INSTRUCTIONAL BULLETIN NO. 15-13

Regarding Revised Standard Drawings

Effective Apr. 1, 2016 letting (Jan. 20, 2016 Turn-in), the following Standard Drawings have been revised. Section V of the Design Guidelines is revised to incorporate these changes.

09-01-12 T-S-23C

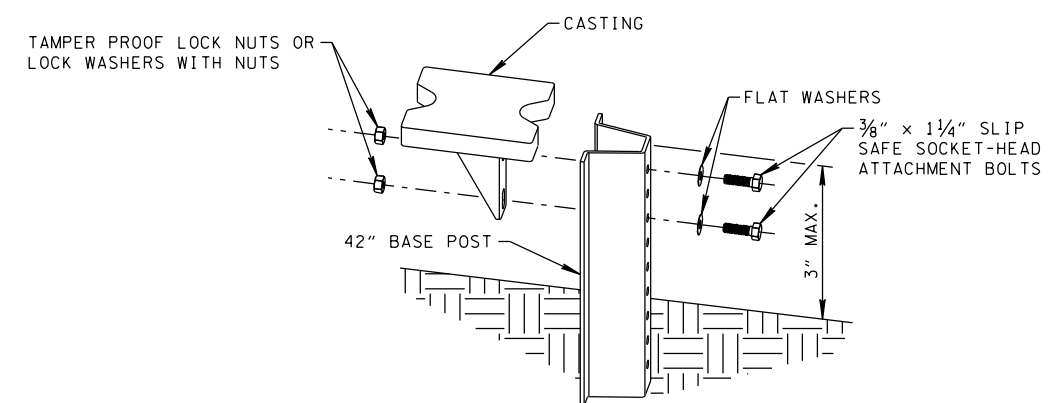
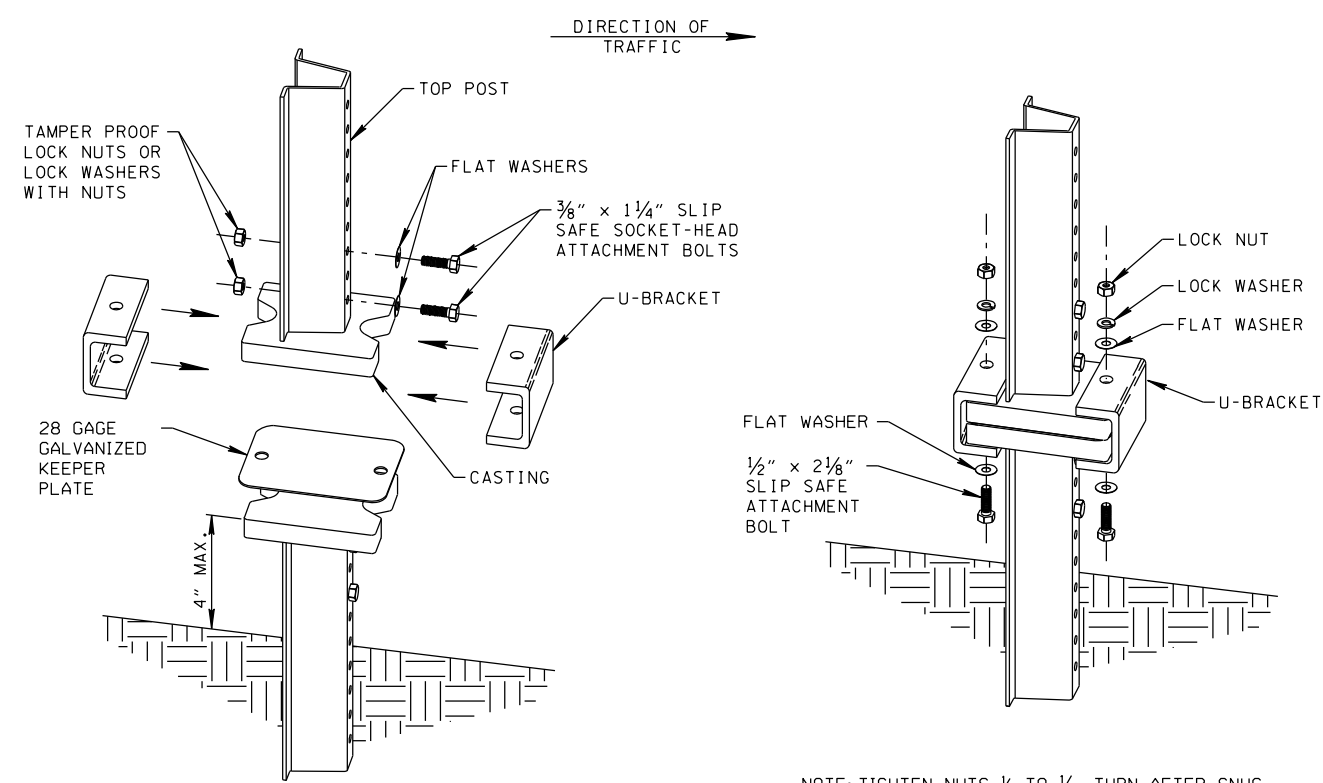
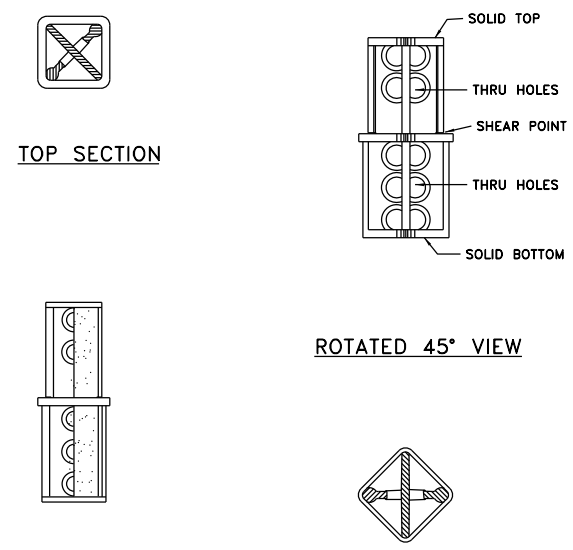
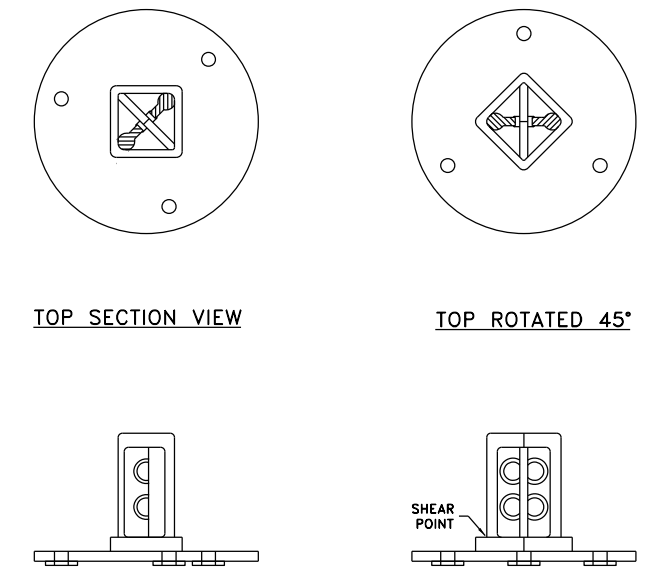
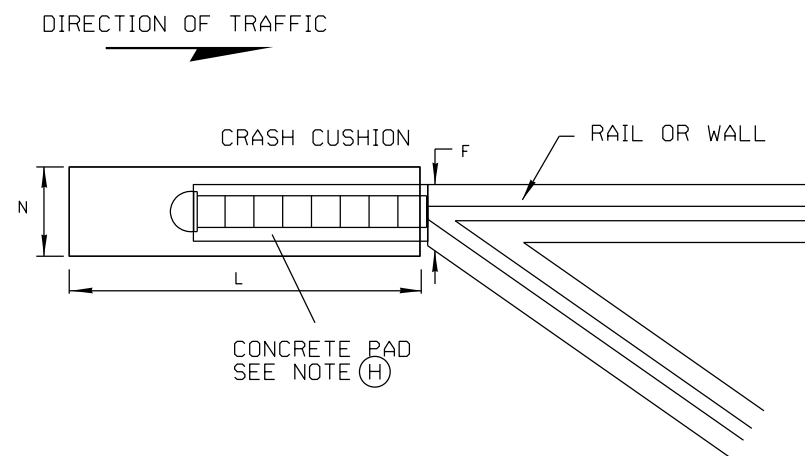
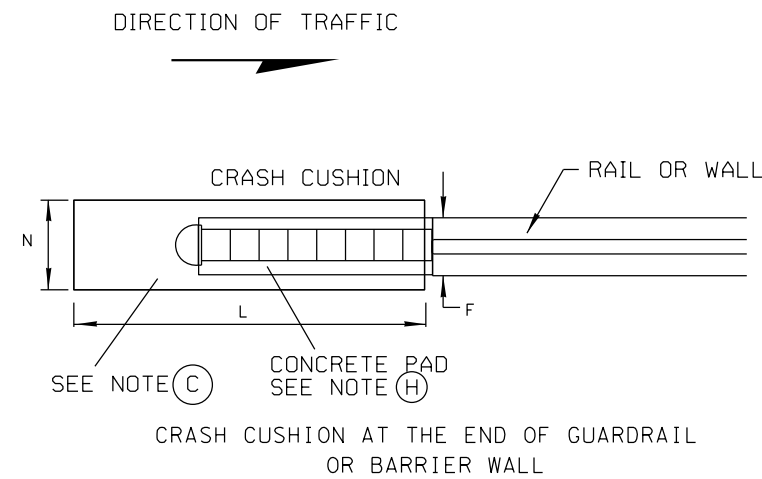
REV. 7-2-15: REVISED NOTE (L) AND ADDED NOTE (N) AND ADDED COUPLING DETAILS AND REVISED GENERAL NOTES. REV. 7-19-13: ADDED NOTE (M)
